**Proposal for ~~corrigendum to draft Supplement 3 to the 032~~  
series of amendments to Regulation No. 117 – Proposal ~~of~~  
~~amendments to~~based on ECE/TRANS/WP.29/GRB/2012/15  
and ECE/TRANS/WP.29/GRB/2012/18**

**Submitted by the secretariat <sup>1</sup>**

The text reproduced below was prepared by ~~ETRTO, NL, UK and Poland~~ to amend UNECE Regulation 117 in order to allow the use of the test track complying to ISO 10844:2011 with transitional provisions.

Figure 1

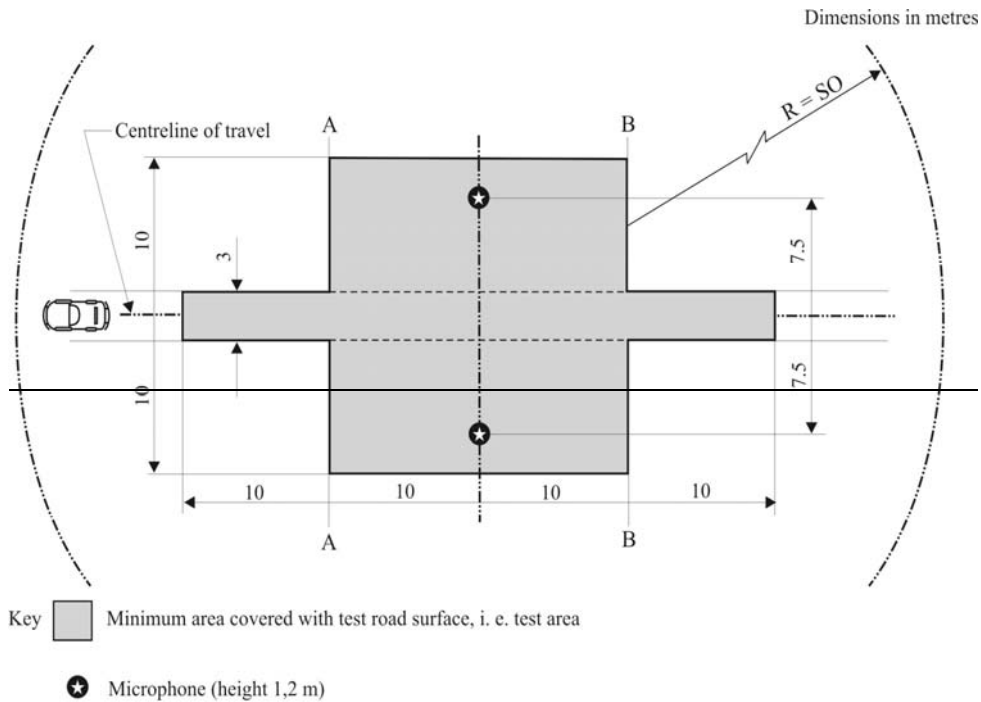
### **~~Specifications for the test site~~**

~~1. Introduction~~

— This annex describes the specifications relating to the physical characteristics and the laying of the test track. These specifications based on a special standard<sup>2</sup> describe the required physical characteristics as well as the test methods for these characteristics.

————— When designing the test track layout it is important to ensure that, as a minimum requirement, the area traversed by the vehicles running through the test strip is covered with the specified test material with suitable margins for safe and practical driving. This will require that the width of the track is at least 3 m and the length of the track extends beyond lines AA and BB by at least 10 m at either end. Figure 1 shows a plan of a suitable test site and indicates the minimum area which shall be machine laid and machine compacted with the specified test surface material. According to Annex 3, paragraph 3.2., measurements have to be made on each side of the vehicle. This can be made either by measuring with two microphone locations (one on each side of the track) and driving in one direction, or measuring with a microphone only on one side of the track but driving the vehicle in two directions. If the latter method is used, then there are no surface requirements on that side of the track where there is no microphone.

## Specifications for the noise test site

This Annex describes the specifications relating to the physical characteristics and the laying of the noise test track. These specifications based on a special standard <sup>3</sup>, describe the required physical characteristics as well as the test methods for these characteristics.

Figure 1  
Size of the test track

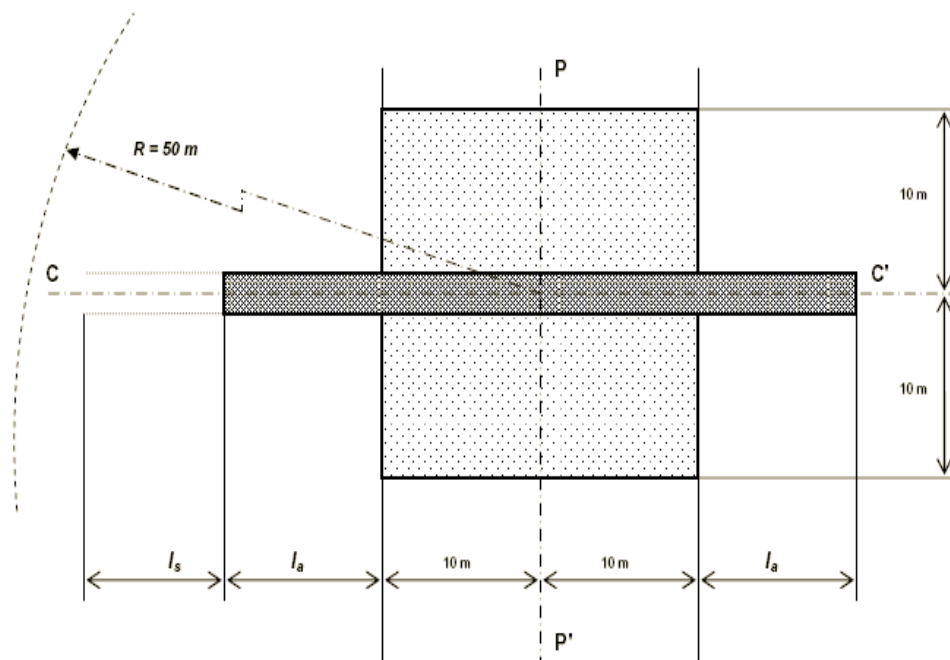
The test track shall consist of two areas, a drive lane and a propagation area. The dimensions shall comply with Figure 1 and Table 1.

A drive lane with a length of  $l_a$  and width of at least 3.0 m that is centered around line PP'. The value of  $l_a$  is defined in Table 1.

The propagation area shall extend at least 10 m from the centre of the drive lane and at least 10 m at both sides of the line PP'.

The space around the centre of the track within a radius of 50 m shall be free of large reflecting objects such as fences, rocks, bridges or buildings.

Figure 2  
Propagation area slope in transverse direction

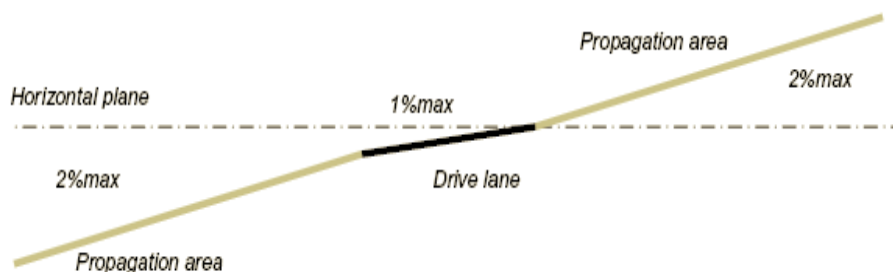
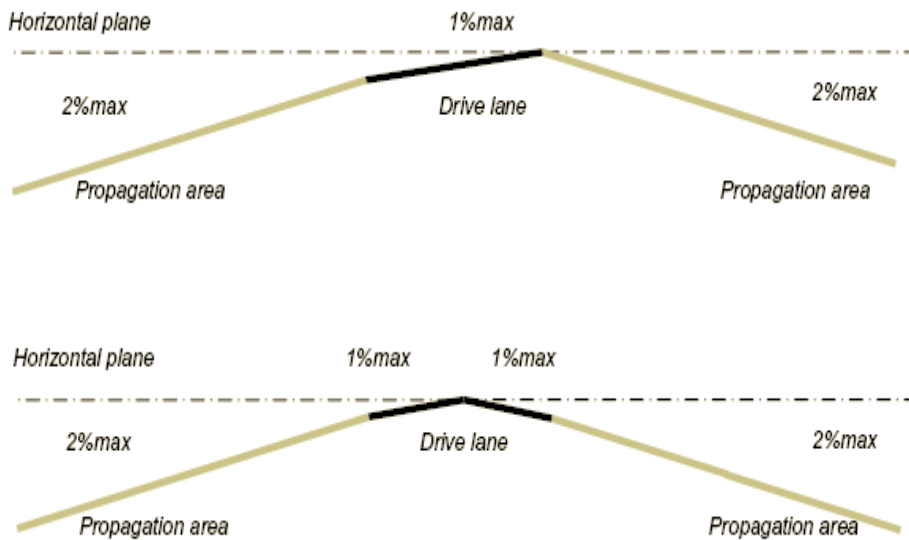
- (i) For acceptance of the test track only, transverse irregularities equal to or less than 0.003 m and longitudinal irregularities equal to or less than 0.002 m measured with the straightedge according to EN 13036-7;
- (ii) For periodical checking of the test track only, transverse irregularities equal to or less than 0.005 m and longitudinal irregularities equal to or less than 0.005 m measured with the straightedge according to EN 13036-7;
- (iii) For acceptance only, deviation from the horizontal plane in transverse direction of 1.0 per cent maximum (see Figure 2) and in a longitudinal direction of 0.5 per cent maximum.

- (i) The propagation area shall have irregularities equal to or less than 0.02 m measured with the straightedge according to EN 13036-7;
- (ii) The propagation area may have one or both sides lower than the drive lane. Cross fall in transverse direction, measured using an appropriate instrument, shall be equal or less than 2.0 per cent (see Figure 2);

**Figure 3**

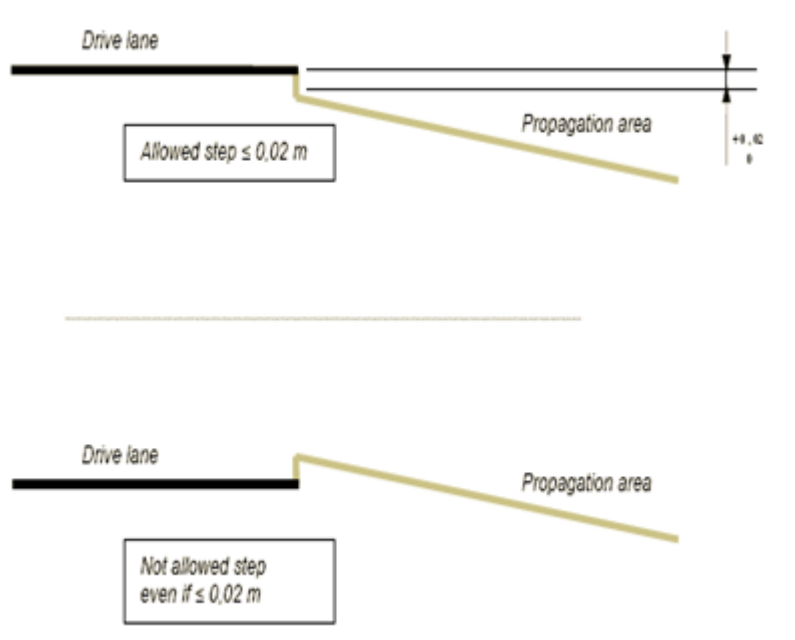
Steps or discontinuities between the propagation area and the drive lane shall be between 0 and +0.02 m. Negative steps are not allowed (see Figure 3).

**Figure 4**  
Sieving curve area

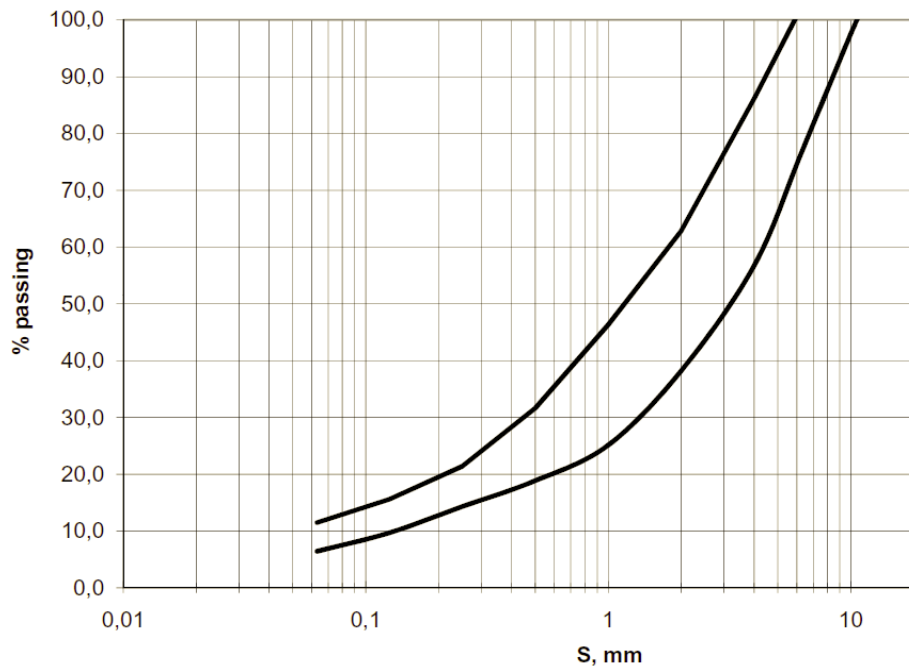
- (a) be of dense asphalt concrete;
- (b) exhibit a sound absorption equal to or less than 8 per cent in any one-third-octave band between 315 Hz and 1 600 Hz when measured according to 4.3;
- (c) have a maximum chipping size of 8 mm (tolerance allowed between 6.3 mm to 10 mm);
- (d) have a thickness of the wearing course greater than or equal to 30 mm;
- (e) have a Mean Profile Depth measured according to ISO 13473-1 of  $0.5 \text{ mm} \pm 0.2 \text{ mm}$ ;
- (f) have a target sieving curve for the aggregate as shown in Figure 4.

Figure 5  
Measurement positions on test track, example for  $l = 40$  m

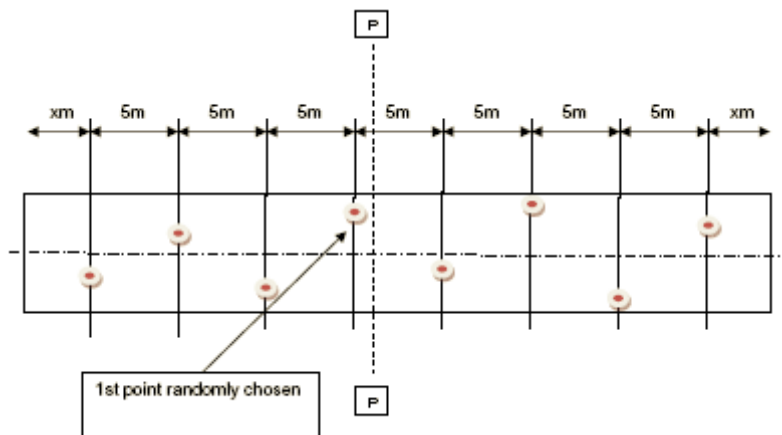
- (b) During the periodical checking of the track (refer to Table 2);
- (c) All measurements shall be made along the total length of the drive lane in each wheel track according to the following scheme to Figure 5;
- (d) For sound absorption, texture, geometrical compliance, the first test point shall be chosen randomly on each side in the vicinity of the line PP' and the subsequent measurements shall be performed at 5 m intervals not on the same axis of the centre line to cover the whole track;
